The Panel
Waihi North Project Fast-track Application
FTA-2504-1046

**RE: Request for information in relation to the Waihi North Project under the Fast-track Approvals
Act 2024**

**OCEANA GOLD (NEW ZEALAND) LIMITED
WAIHI NORTH PROJECT
FAST TRACK APPROVALS ACT APPLICATION
RESPONSE TO REQUEST FOR INFORMATION ON STORAGE 3 TAILINGS
STORAGE FACILITY (TSF3)**

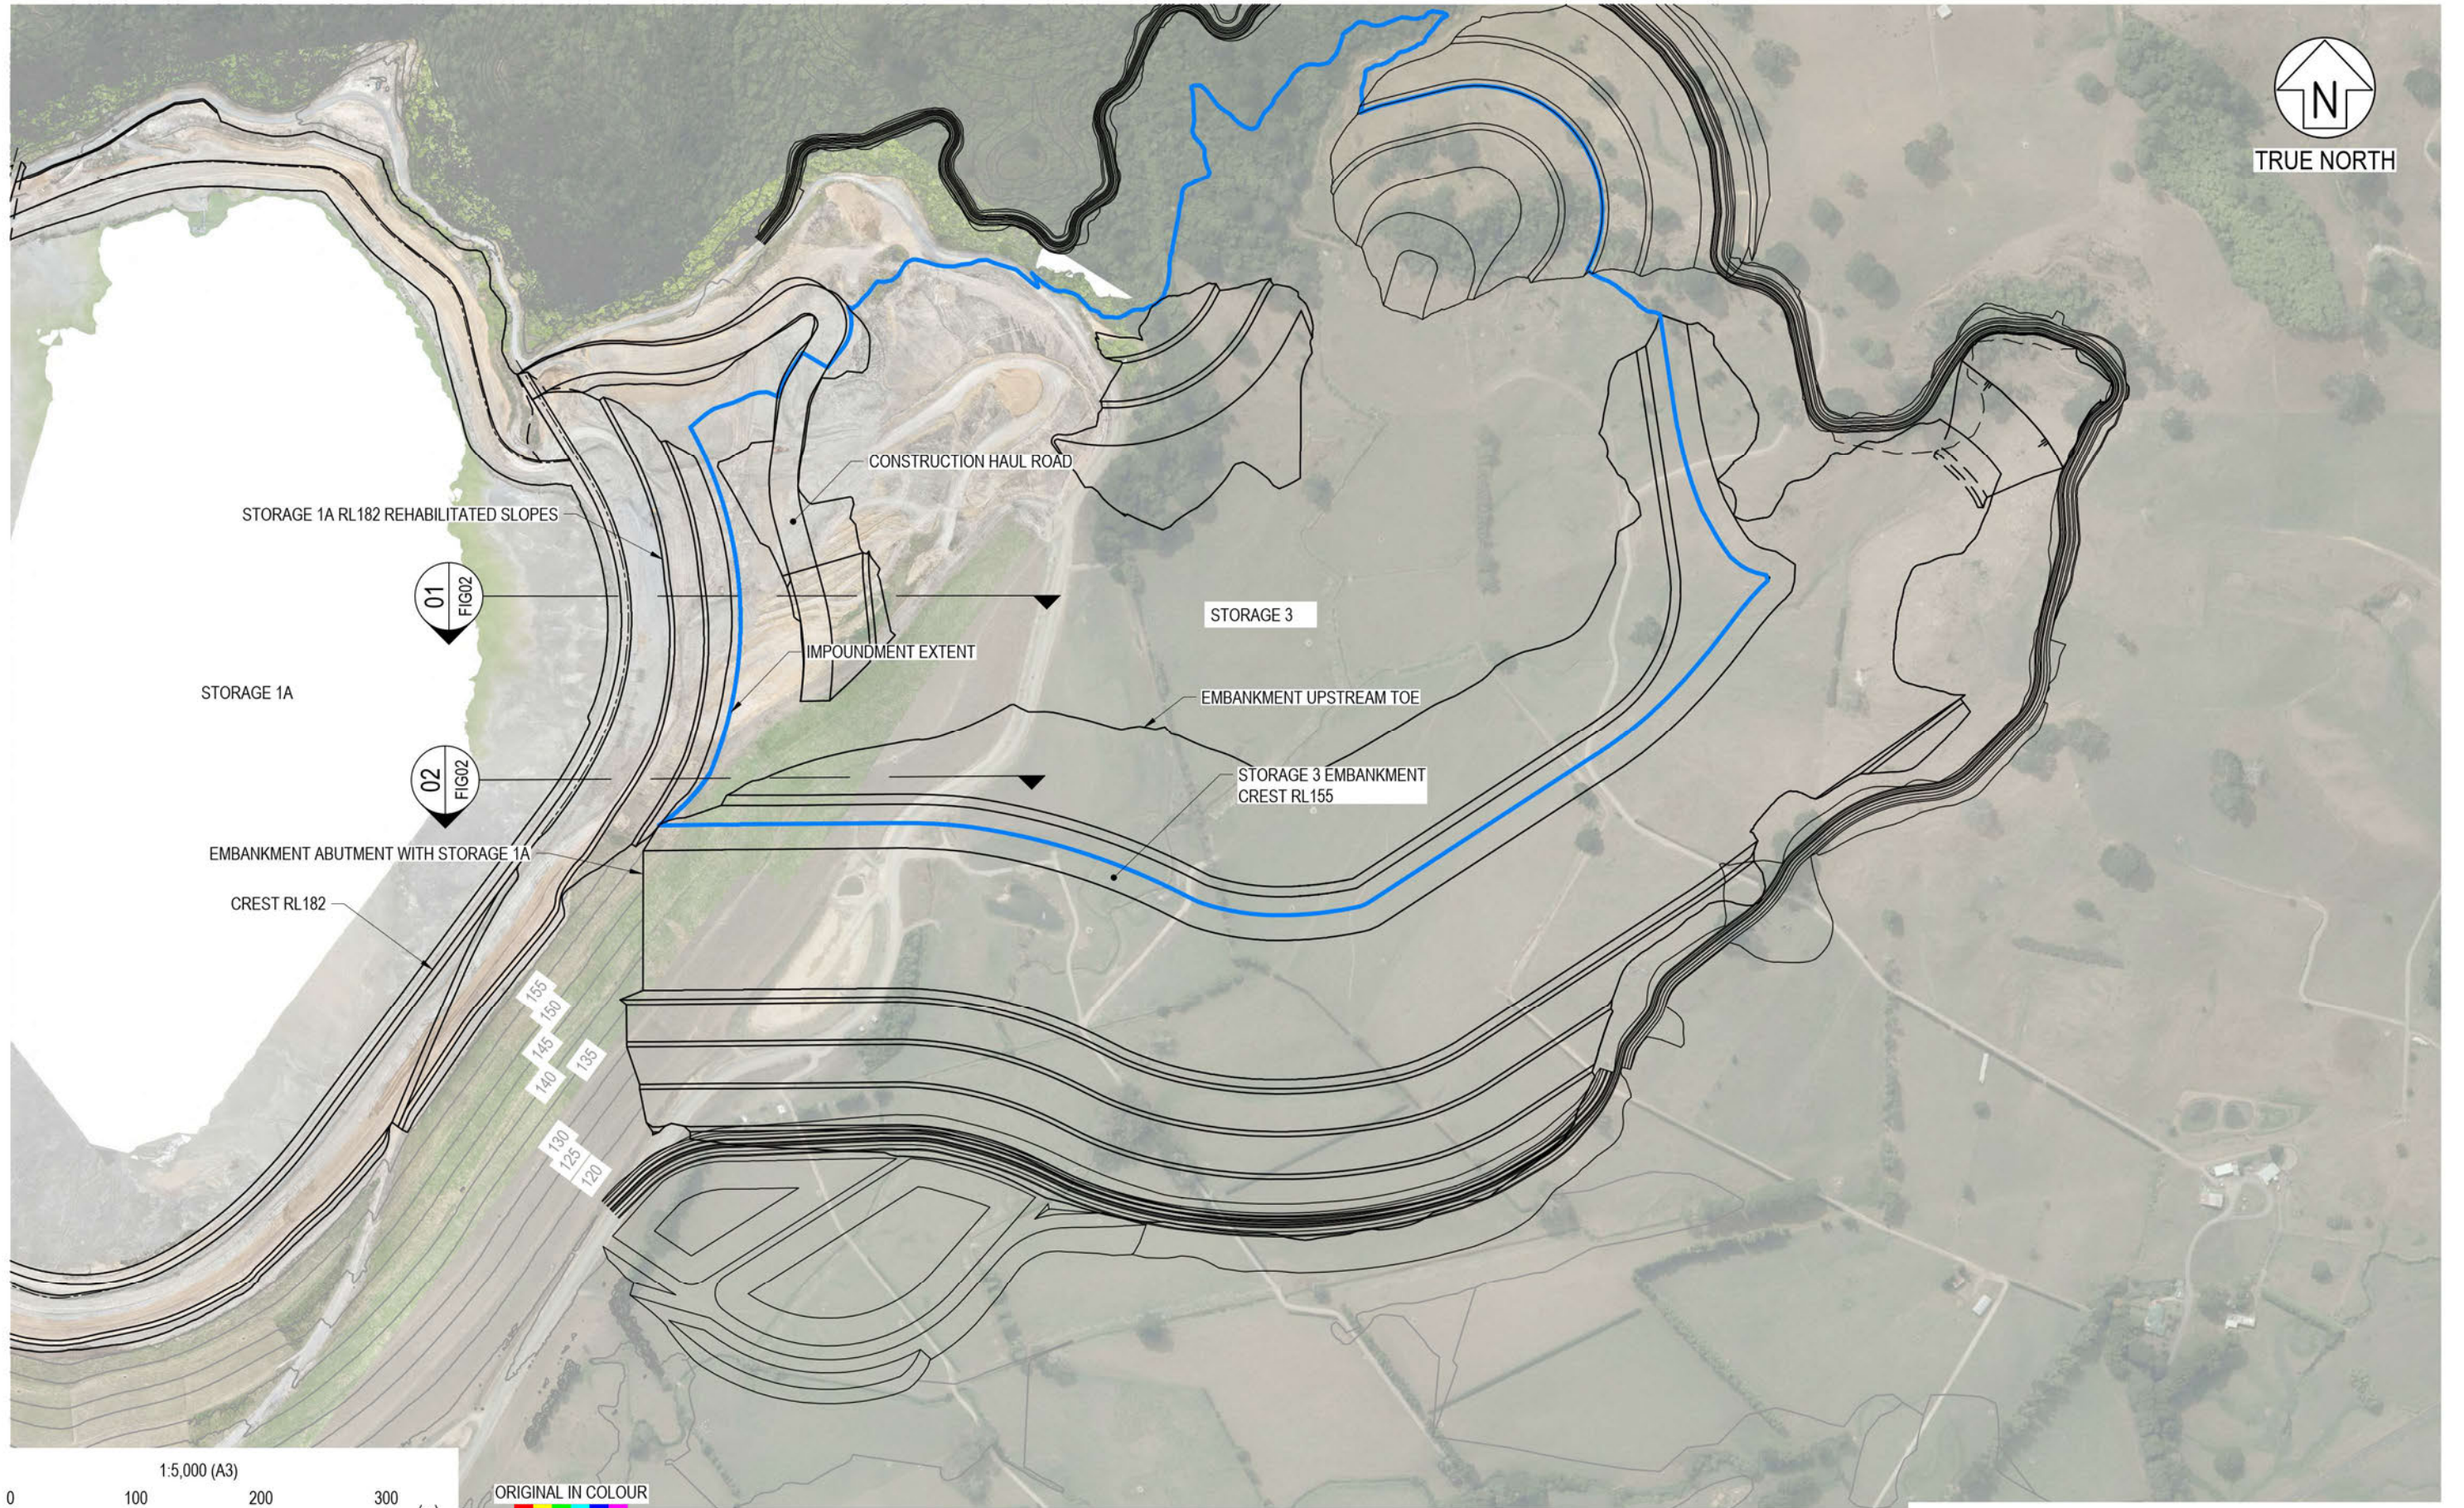
Please provide a cross section that extends through the as-built for tailings Storage 1A and the design for TSF3 so that we can better understand the integration of these two storage facilities.

- Figure 1 attached shows the location of two cross sections showing the current proposed detail for the TSF3 abutment with TSF1A. Figure 2 shows the cross sections. Section 1 shows the TSF3 tailings against the TSF1A embankment. Section 2 shows the TSF3 tailings and embankment in contact with the TSF1A embankment just upstream of the TSF3 crest contact with TSF1A.
- The design concept is that the upstream zones (Zones B, C1 and C2) wrap around the inside of the impoundment and against the Storage 1A embankment. The embankment bulk fill zones become joined and the outer rehabilitation layers become continuous.

FIGURE 03

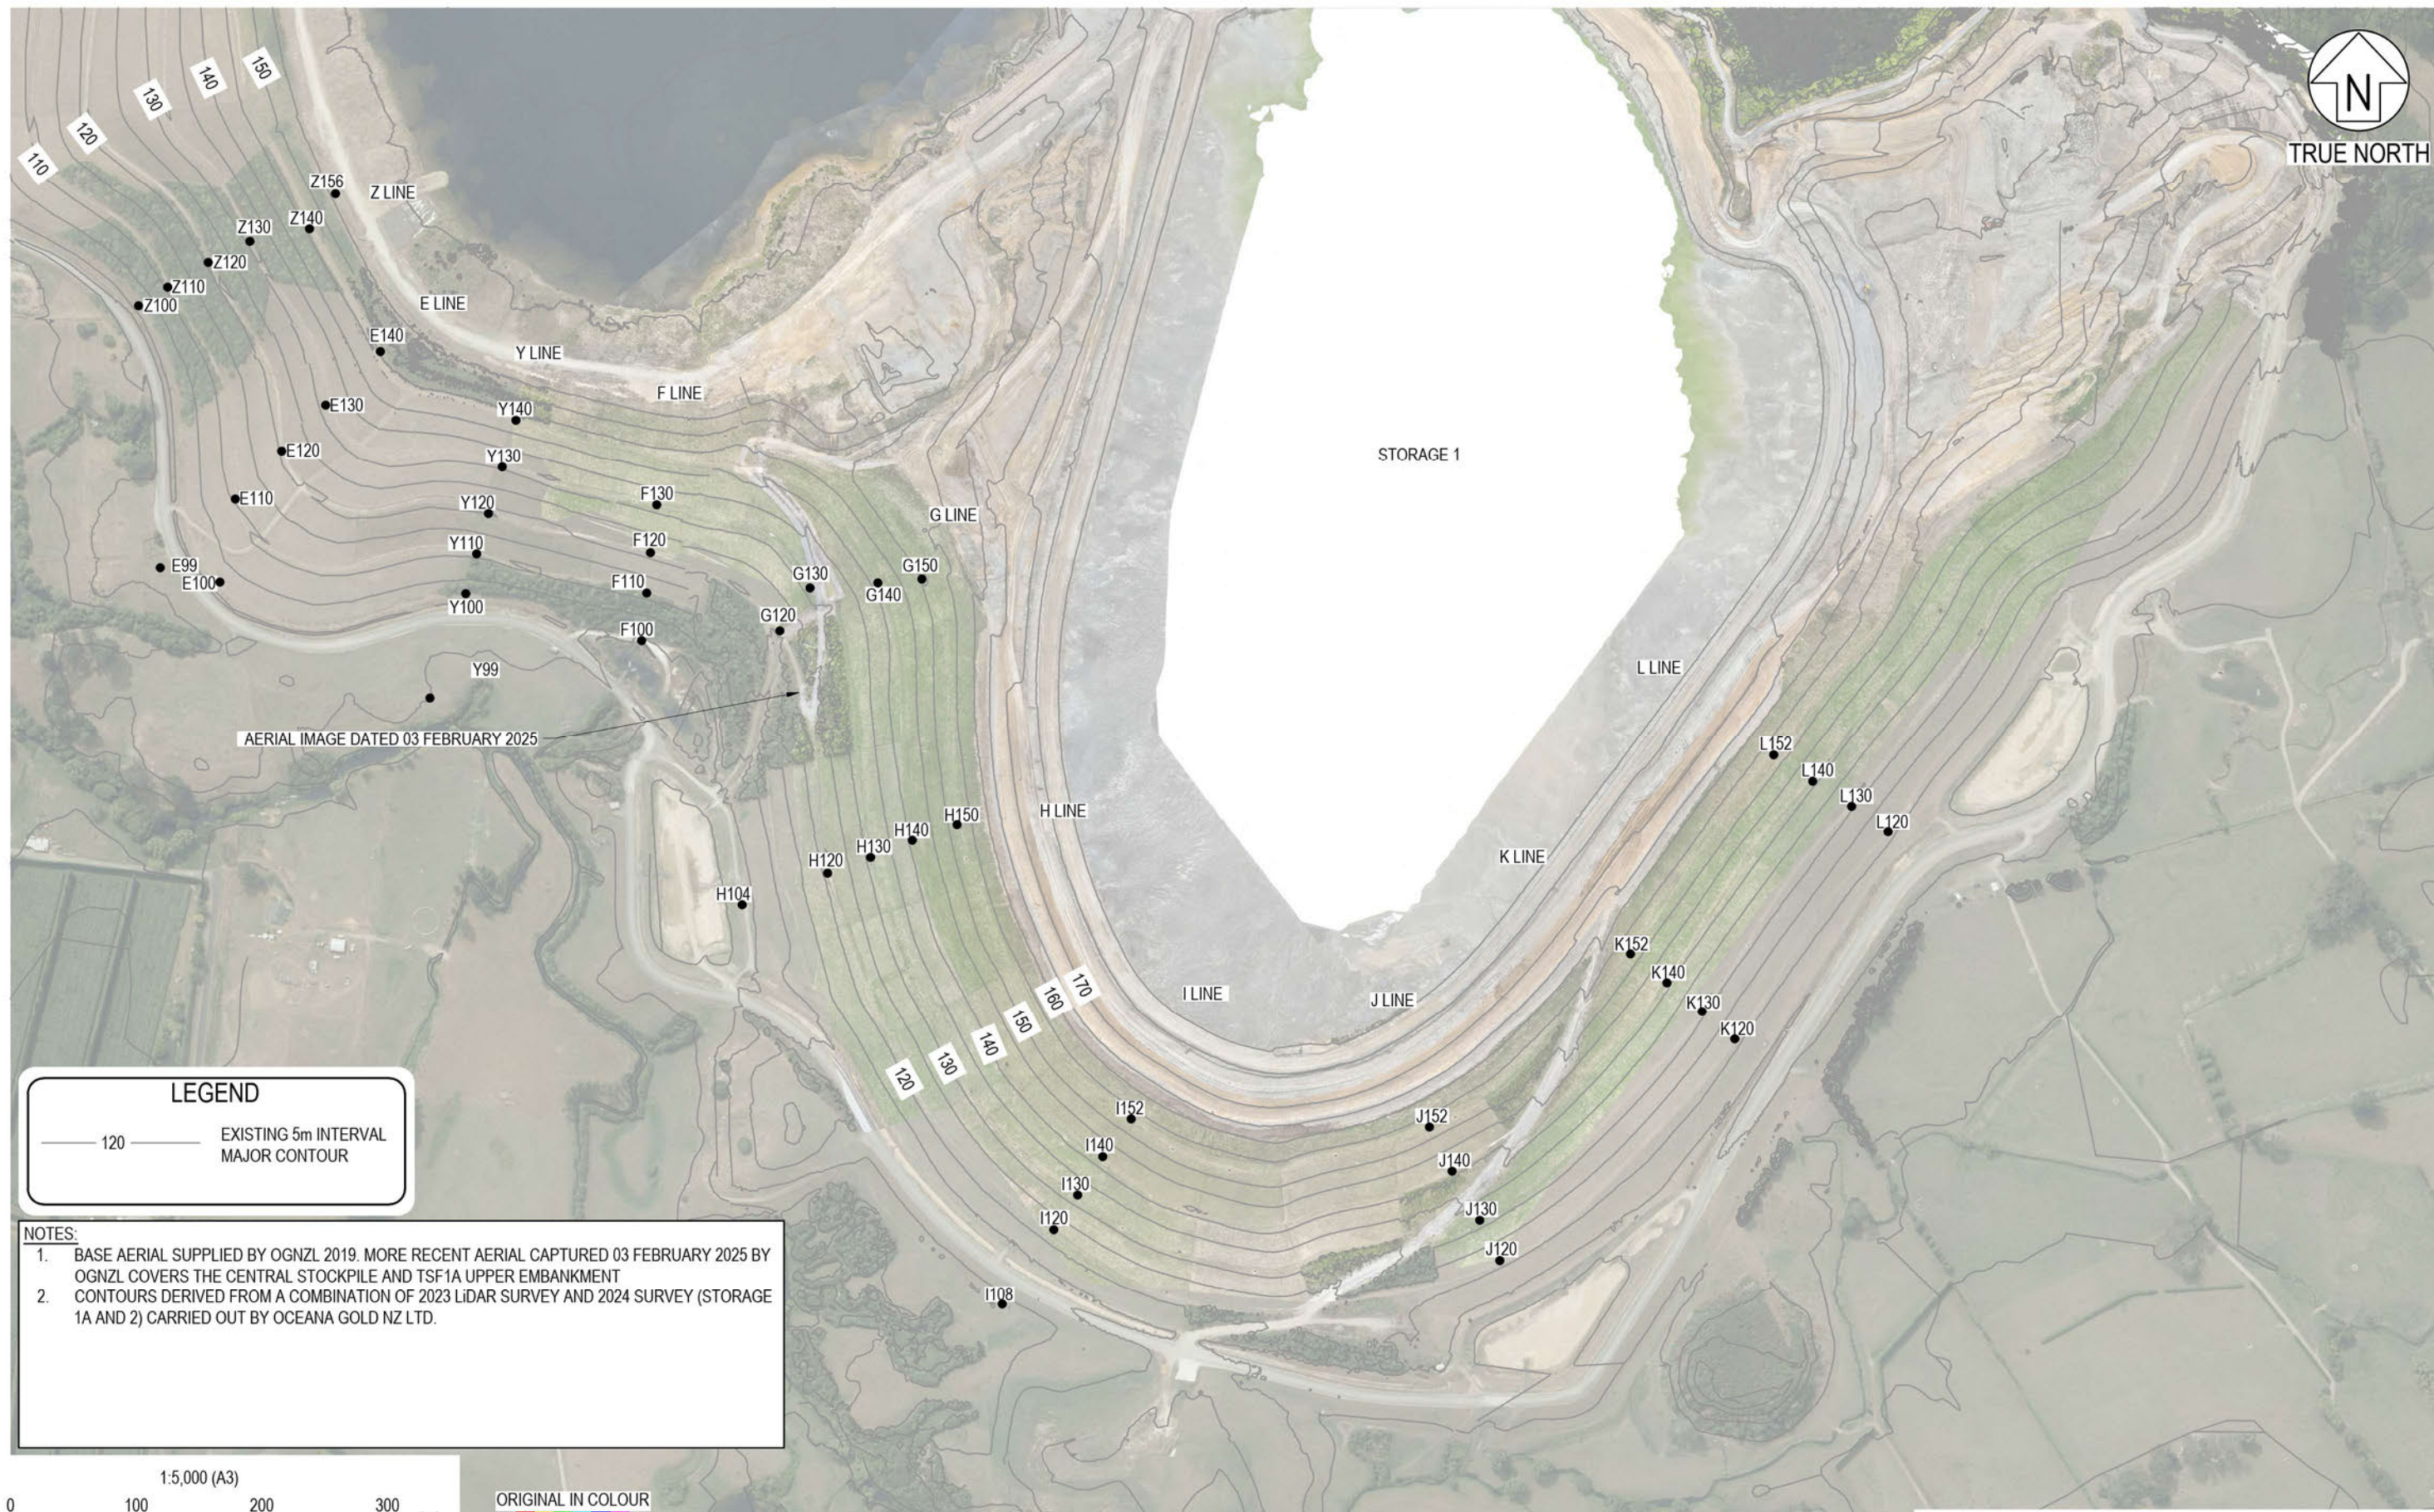
Coromandel Watchdog commented that accurate monitoring of existing waste rock piles and tailings facilities was needed. OGNZL responded that these sites are extensively instrumented, however there is no information provided that summarises the outcomes of that monitoring. Performance of the existing rock stacks and tailings areas is pertinent to the expected performance of future rock stacks and tailings areas. Please provide a summary of the outcomes of monitoring of Tailings Storage 1A and 2 and existing rock stacks.

- In regard to dam safety and structural integrity:
 - TSF1A has 26 deformation benchmarks installed as shown on Figure 3 attached.
 - TSF2 has 41 deformation benchmarks installed as shown on Figure 4 attached.

- The visual monitoring and deformation survey indicates both TSFs are stable with very small deformations. This is attributed to the rigorous specifications for fill placement and compaction within the zoned embankments.
